**Petition of BNE Energy Inc. for a  
Declaratory Ruling for the Location,  
Construction and Operation of a 4.8 MW  
Wind Renewable Generating Project on  
Flagg Hill Road in Colebrook,  
Connecticut (“Wind Colebrook South”)**

**Petition No. 983**

**PRE-FILED TESTIMONY OF NOISE CONTROL ENGINEERING, INC.,  
BY MICHAEL BAHTIARIAN, INCE Bd. Cert.**

**Wind Colebrook South  
Noise Monitoring and  
Receptor Locations**  
29 Flagg Hill Road  
Colebrook, CT

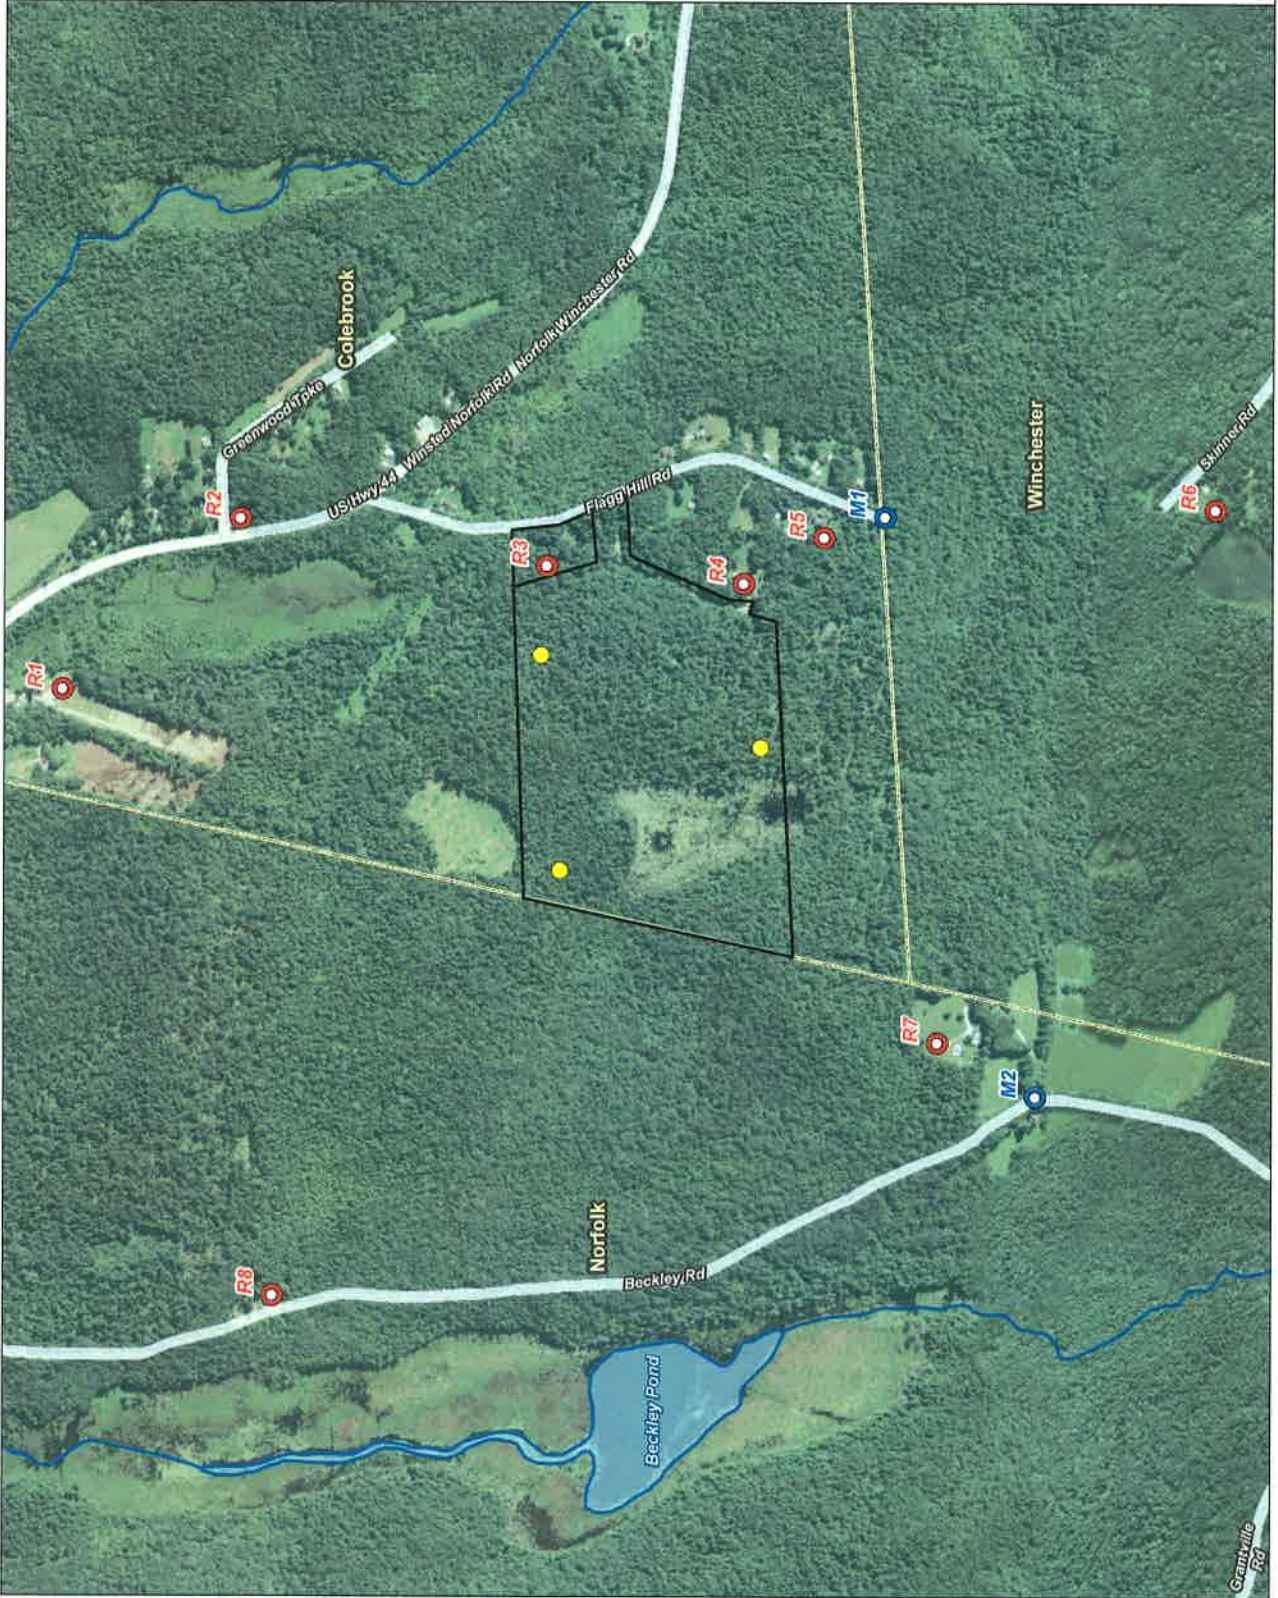
A24. I have reviewed the Noise Monitoring Summary provided in the Appendix. NCE Exhibit 4 is a table summarizing the start times and duration of each measurement taken from the monitoring logs provided in the appendix. The table shows that the noise measurements at the sites were only performed for fifteen to twenty minutes. There is one set of data reported in Table 4 of the report for which no measurements appear to be taken. No monitoring appears to be performed at Beckley Road (M2) during the day.

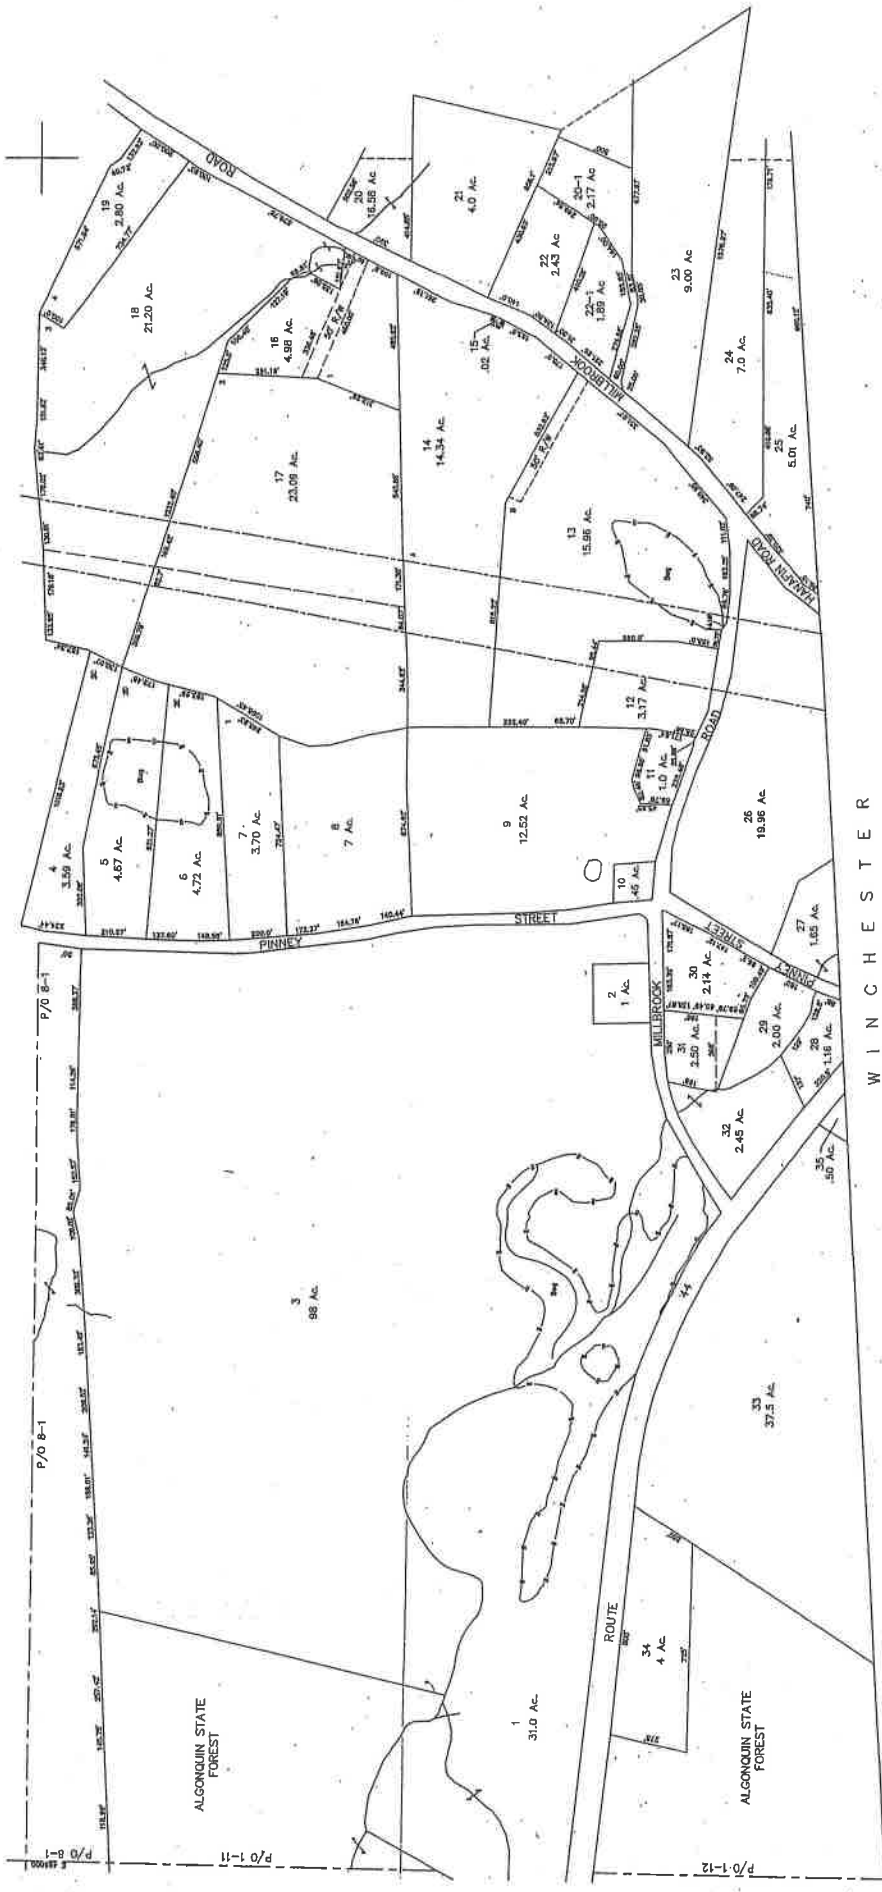
The value of atmospheric absorption factor used for the Wind Colebrook North is 5 dB/km (0.005 dB/m) which is found at the top of the sound computation worksheets under the heading absorption coefficient. Based on examination of ISO-9613-2, the factor appears to be for the condition of 20°C (68°F), 70% RH and 1,000 Hertz octave band. According to ISO-9613-2

when performing the computations in overall A-weighted SPL the atmospheric absorption factor for the 500 Hertz octave band should be used. Accordingly, the value of the factor that should have then been used for the above meteorological conditions is 2.8 dB/km. Further, for a worst case situation the minimum factor should be used which would have been at meteorological conditions of 10°C (50°F), 70% RH. In this case the value would be 1.9 dB/km. In many of my evaluation studies I have not taken into account this factor (i.e. the coefficient is set to 0 dB/km). This would provide an even more conservative assessment.

The lower the atmospheric absorption factor the higher the predicted SPL. The report's conclusion states that the computation is a "worst case analysis". This does not appear to be the case. If the 1.9 dB/km value were to be used the predicted SPL would be 1 to 5 decibels higher. If no atmospheric absorption was taken into account (0 dB/km) the predicted SPL would be 2-8 decibels higher.
